Integrator/CM7TDMI User Guide

ARM DUI 0126B

Errata 01

This errata corrects incorrect information given in the diagrams in section A.2 of the user guide.

Figure A-2 HDRB socket pin numbering

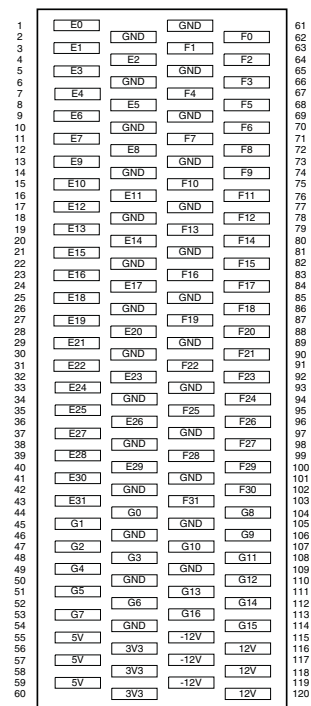
In Figures A-2 and A-3, pins 110 and 111 are incorrectly given as 150 and 151. The corrected figures are shown below.
